NYN-00080

Seabrook Station

“Response to Request for Additional Information Pertaining to
the 2nd Ten-Year Interval Inservice Test Program Relief Request PR-1”

CBS Pump Testing Issues:

CBS Pump 9A Performance Curves

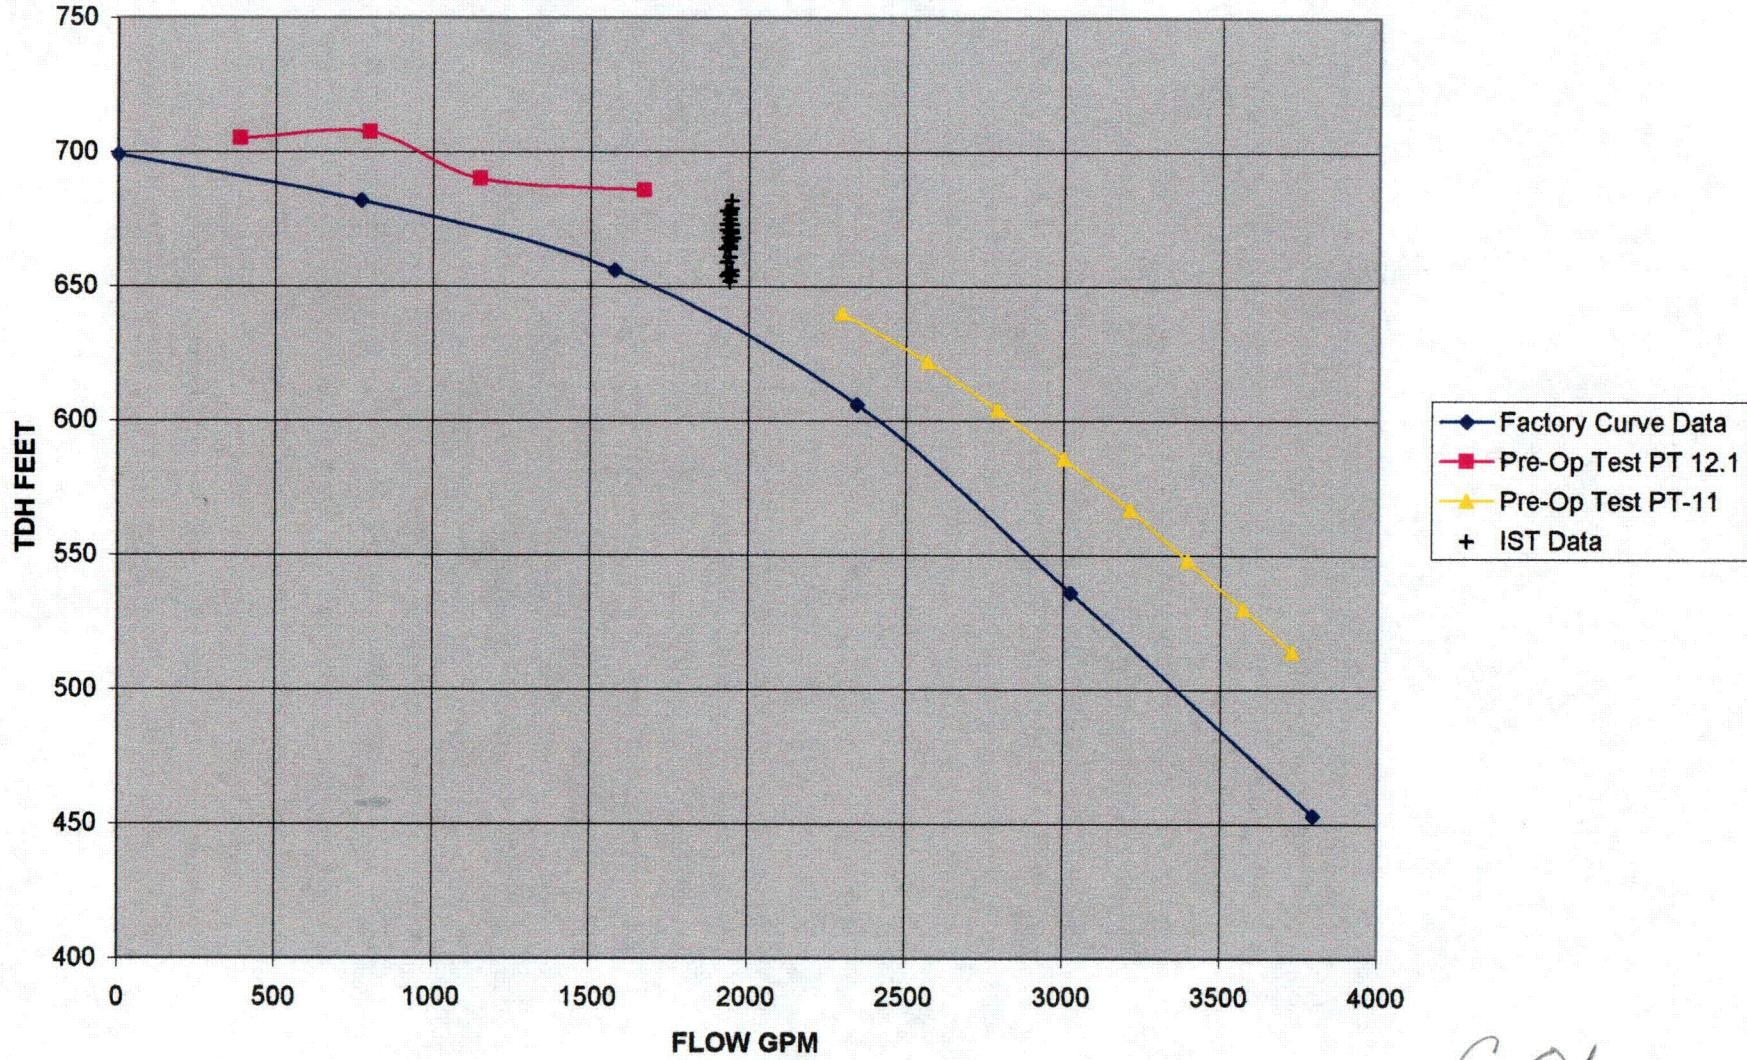
The CBS pumps are typically used for test purposes or to recirculate the contents of the RWST. Typical run times per year are less than 50 hours. To demonstrate that IST data is fairly consistent, IST data has been provided in Enclosure 2 in a graphical form and in a short table format. Even though this data is only at one flow point, it has been very consistent since the pre-operational test data was taken.
